**CULTURAL RESOURCES OFFICE
PRESERVATION BOARD
REGULAR MEETING
MONDAY – OCTOBER 26, 2015 — 4:00 P.M.
1520 MARKET ST. #2000
ST. LOUIS, MO. 63103
www.stlouis-mo.gov/cultural-resources**

DATE: October 26, 2015
ADDRESS: 2716 Indiana Avenue
ITEM: Preliminary Review: construction of a new single-family house
JURISDICTION: Benton Park Local Historic District — Ward 9
STAFF: Jan Cameron, Cultural Resources Office

FRONT FACADE

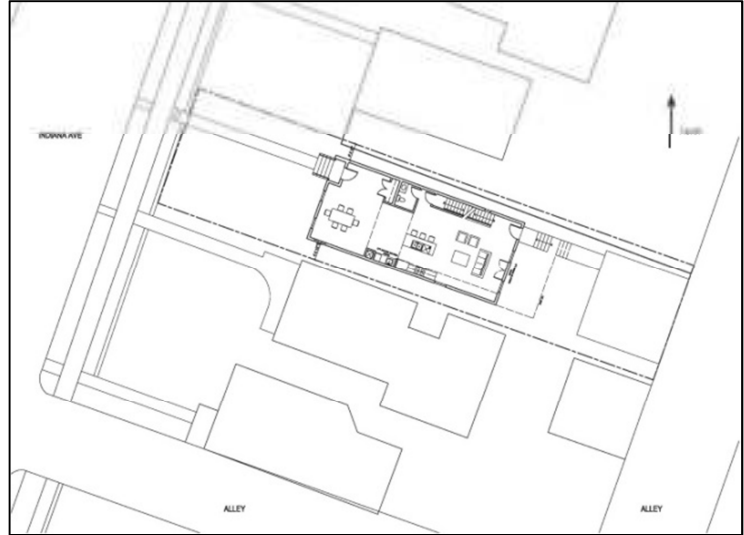
Does not comply. The windows of the front elevation are generally compatible with adjacent residential buildings, although they do not duplicate their details and trim, nor do they follow those of the Model Example.

However, the front façade presents a 2-story entry bay that rises to a wide wall dormer with large fixed window. The elements of this bay do not approximate the proportions of any similar elements on building in the district and the dormer design particularly is over-scaled and visually dominates the front façade.

Partly complies. The front elevation will be veneered in red brick. Both side elevations, which will be partly visible, will have a two-foot brick return; the remainder of the first 16 feet will be sheathed with fiberboard cement panels of varied sizes placed in an irregular pattern and painted a gray color. The use of flat concrete panels was agreed to by the Cultural Resources Office as an acceptable compromise to a larger brick return, the cost of which, the developer indicated, would have made the project economically infeasible. However, the panels were to be painted to match the façade brick. The proposed change to gray with the addition of a very irregular pattern of panel sizes and arrangement, work against any attempt to blend the new design into what is an entirely brick streetscape. The rear portion of each side facade will have painted lap siding.

Does not comply. As stated above, the sides of the building will be painted gray and will not replicate the color of a brick building.

STAFF RECOMMENDATION:
That the Preservation Board grant preliminary approval for the new construction, with the stipulation that the design of the front entry bay and dormer be reconsidered, the proposed and final drawings, materials and colors be reviewed and approved by the Cultural Resources Office.

PROPOSED BUILDINGS IN CONTEXT WITH EXISTING FABRIC

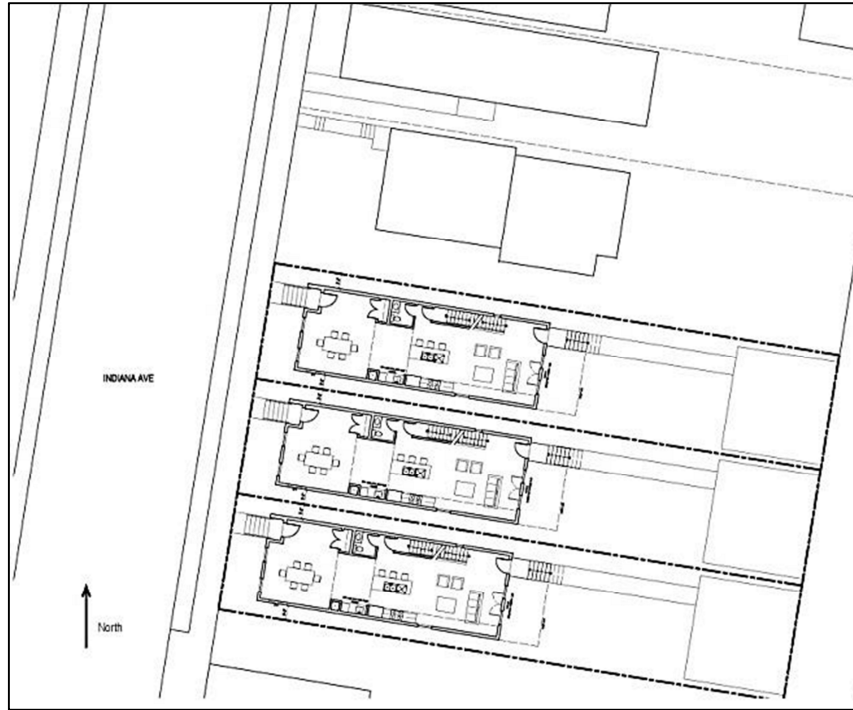
Does not comply. The windows of the front elevation are generally compatible with adjacent residential buildings, although they do not duplicate their details and trim, nor do they follow those of the Model Example.

However, the front façade presents a 2-story entry bay that rises to a wide wall dormer with large fixed window. The elements of this bay do not approximate the proportions of any similar elements on building in the district and the dormer design particularly is over-scaled and visually dominates the front façade.

- The scale of several elements of the front façade and the color proposed for the side elevations are not compatible with the existing historic fabric.

That the Preservation Board grant preliminary approval for the new construction, with the stipulation that the design of the front entry bay and dormer be reconsidered, and final drawings, materials and colors be reviewed and approved by the Cultural Resources Office.

FRONT ELEVATION

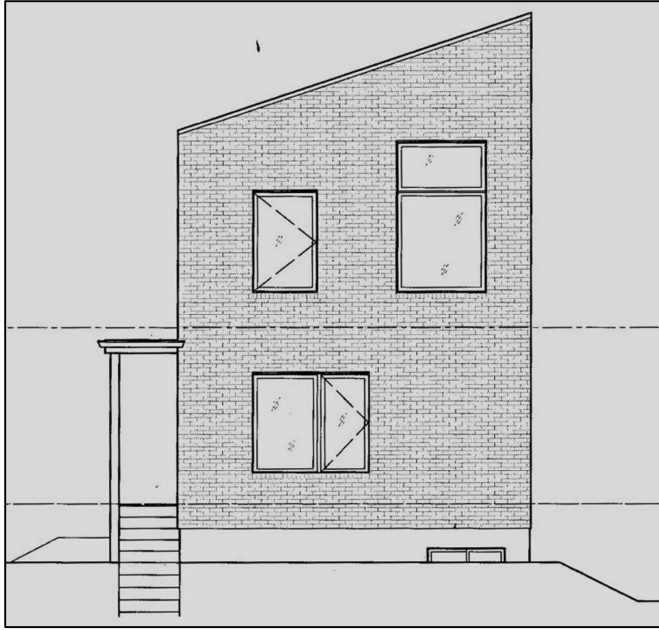
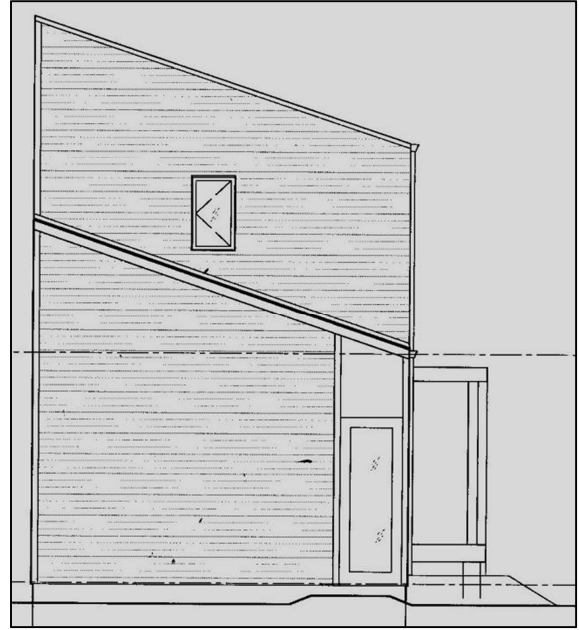
A wood privacy fence of horizontal boards is proposed to enclose the east side yard. While the material and placement comply with the standards, the design is contemporary and not compatible with the historic character of the district.

Based on the preliminary findings, the Cultural Resources Office recommends that the Preservation Board grant preliminary approval to the proposed design, with the condition that proportions and size of the front windows be revised, and the pattern of cement panels be simplified and regularized to bring the project into compliance with the historic district standards, and that final plans, exterior materials and colors be reviewed and approved by the Cultural Resources Office.

PROPOSED SITE PLAN

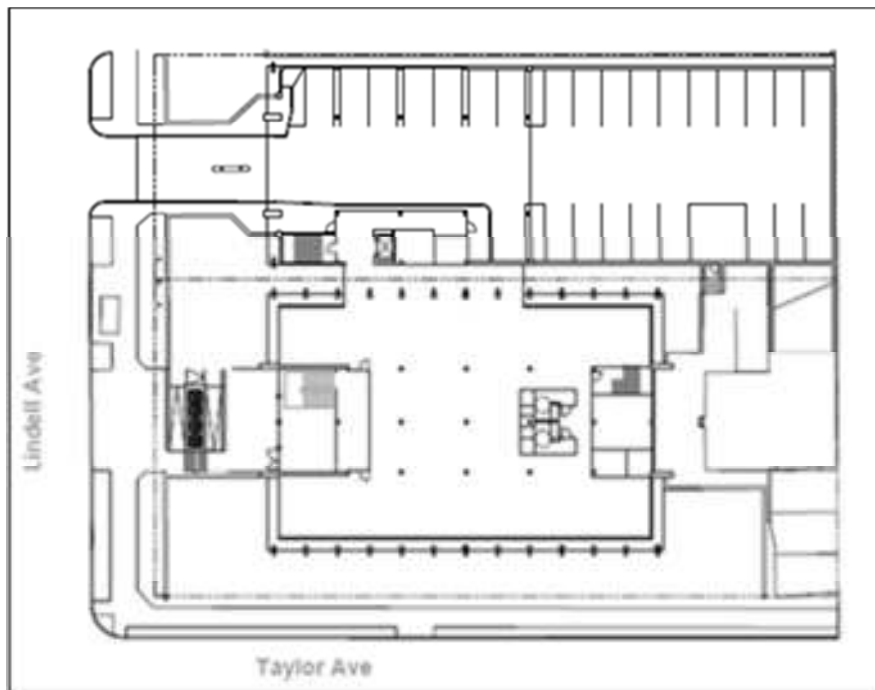
- This proposal does not meet the intent of the historic district standards for maintaining the historic materials and character of the exterior walls and windows.

- The travertine tile exterior of the walls of the pavilion is applied directly to material behind it in an atypical construction method. The applicant's architect describes it as a "tiled interior partition wall" placed to perform as a "mass wall."

- The creation of an accessible main entrance is proposed by excavating down to provide an at-grade main entrance into the lower story in the Lindell façade.

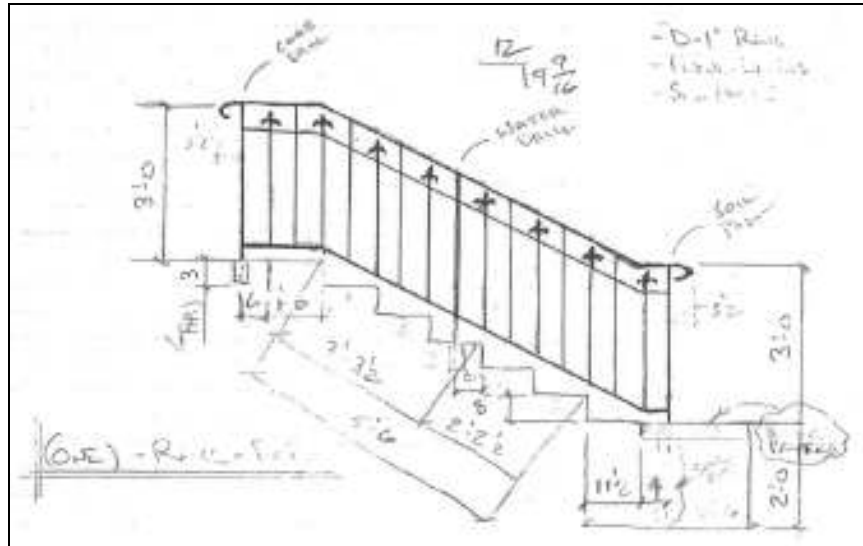
Does not comply. Proposed handrail is based on a fence design, not an appropriate historic handrail design.

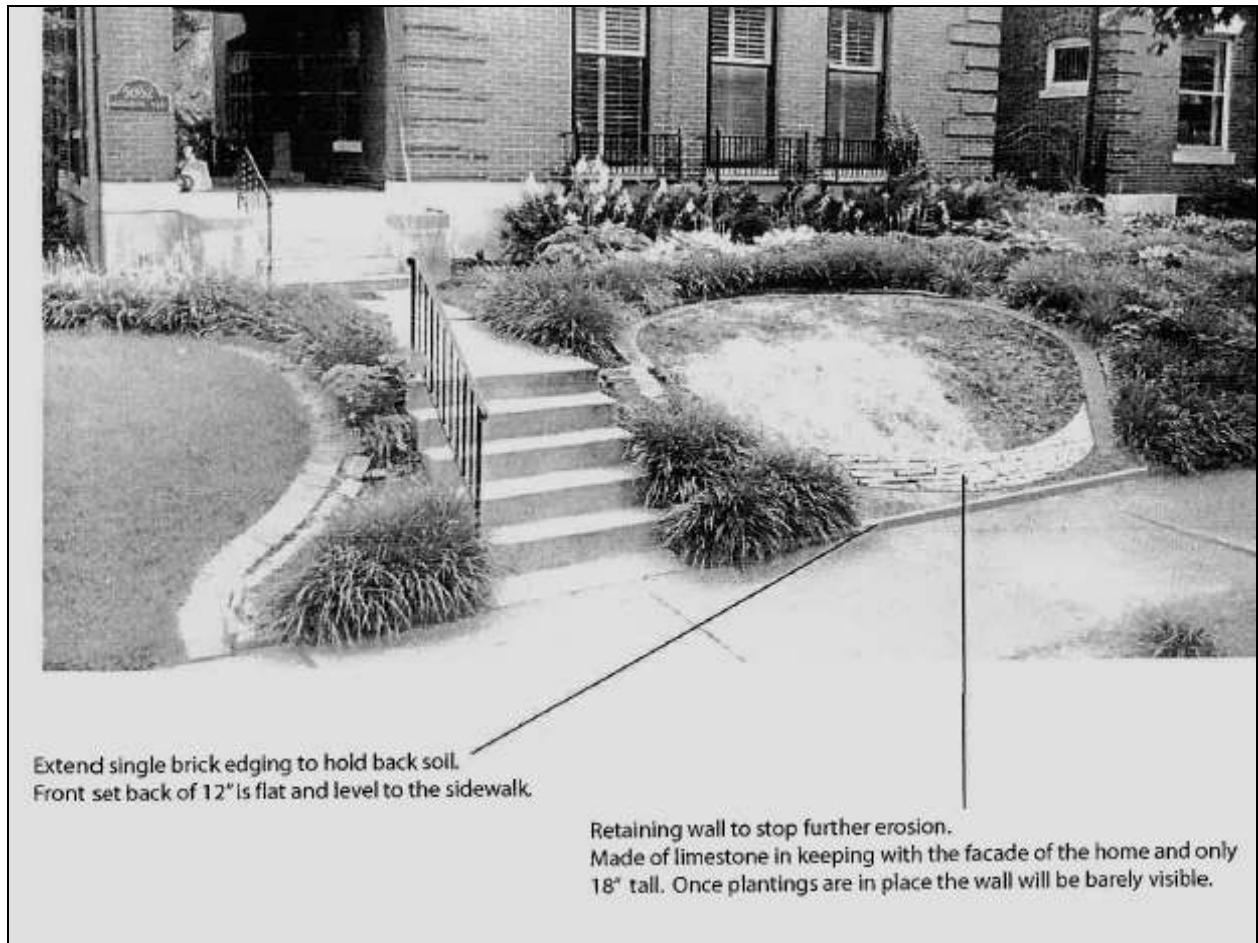
Does not comply. The proposed project would alter the original terrace. The terrace has been excavated but additional work stopped when a neighbor confronted the owner regarding required permits.

SITE PLAN SHOWING PROPOSED FENCING

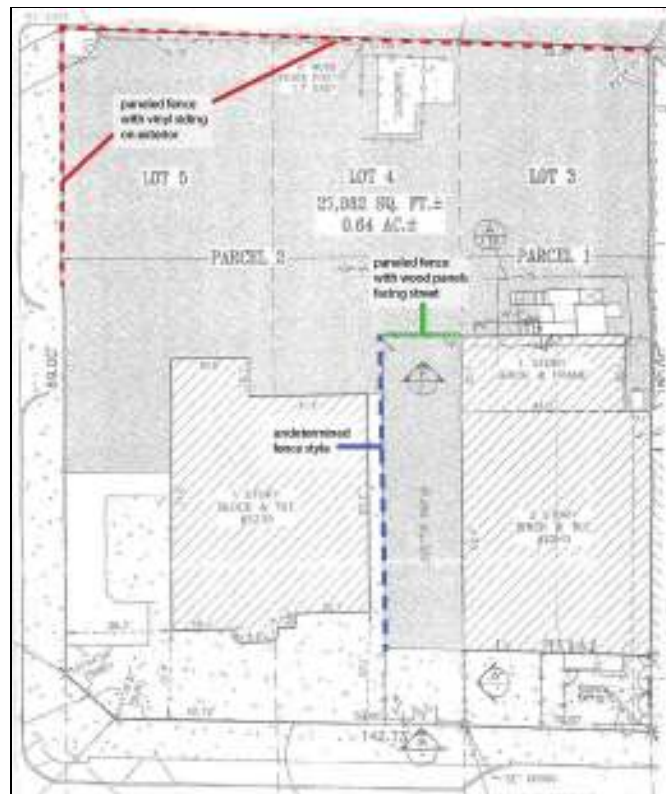
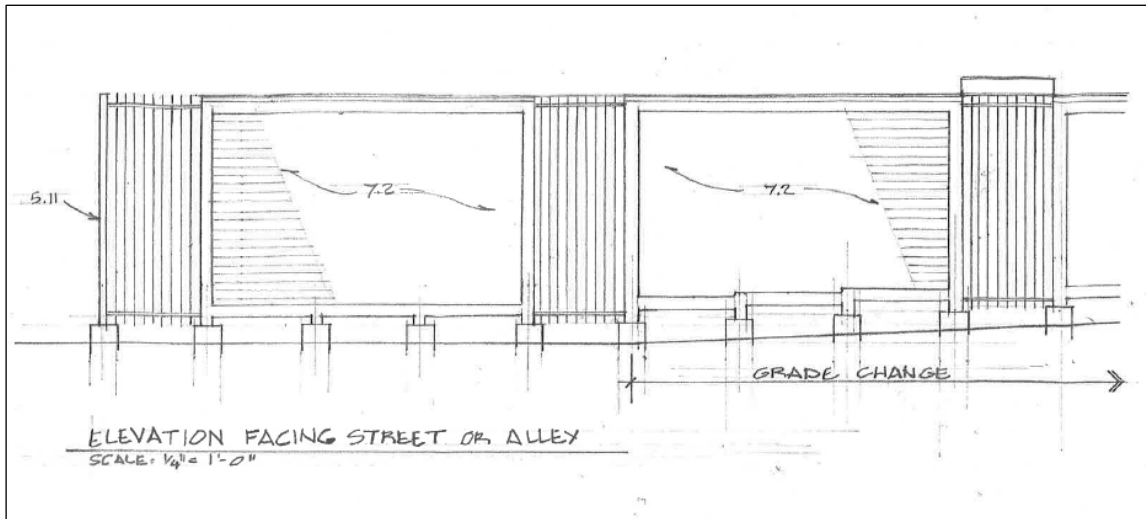
Does not comply. The proposed fence is of a contemporary design which is not compatible with the character of the neighborhood. The exterior of the fence, exposed to street view, will be primarily vinyl lap siding, which is not an approved material for fences in the neighborhood. Some of the fence materials proposed to be used and the graphic elements are unclear on the submitted plans. The fence is proposed to be 10 feet in height which is 4 feet above the maximum fence height in the standards.

- 2245-47 S. Grand Boulevard is located in the Shaw Neighborhood Local Historic District.
- The fence's contemporary design, including graphic elements, is not compatible with the character of the historic district.
- The vinyl siding proposed for outward-facing portion of the fence is not an approved material under the historic district standards. It is unclear from the plans what the materials will be for some other portions of the fence.
- The fence is proposed to be 10 feet in height, 4 feet above the maximum height allowed under the historic district standards.

Based on these preliminary findings, the Cultural Resources Office recommends that the Preservation Board uphold the Director's denial of the application to install a fence as it does not comply with the Shaw Neighborhood Local Historic District standards.
